Airworthiness Directive

AD No.: 2025-0205R1

ATR 42 and ATR 72 aeroplanes

ATA 53 – Fuselage – Passenger Seat Tracks – Inspection / Replacement

Appendix 2- Identification of 'UACE' seat tracks manufactured in or after 2024

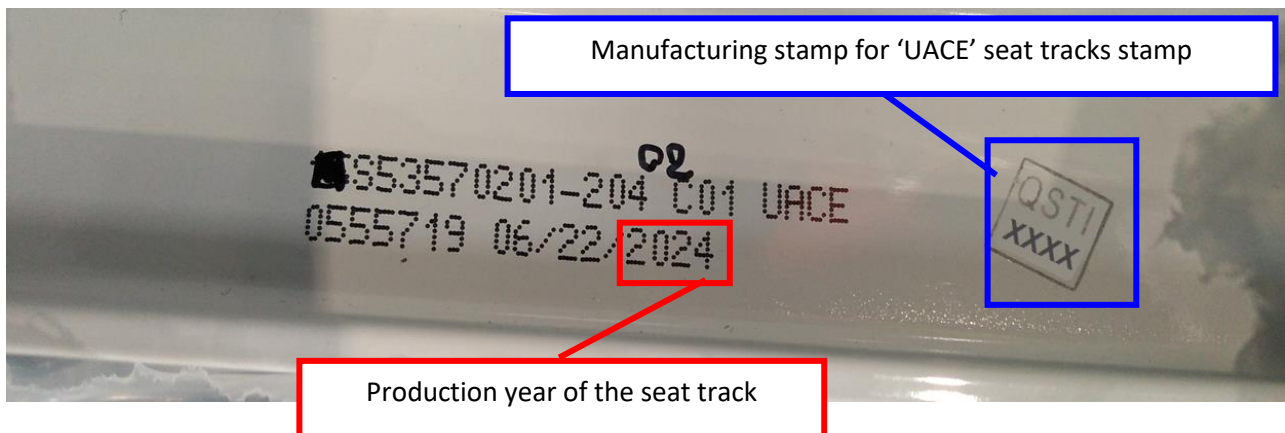
The identification of the seat track is located on the lower face of the seat track.

The manufacturing stamp of the seat track on the illustration corresponds to 'UACE' manufacturer, where 'XXXX' represents any numerical sequence.

The production year of the seat track on the illustration is 2024.

All the seat tracks having this manufacturing stamp and a production year equal to or above 2024, do not have to be considered as affected parts.

All the seat tracks with the manufacturing stamp and/or production year not visible/legible, have to be considered as potential affected parts.
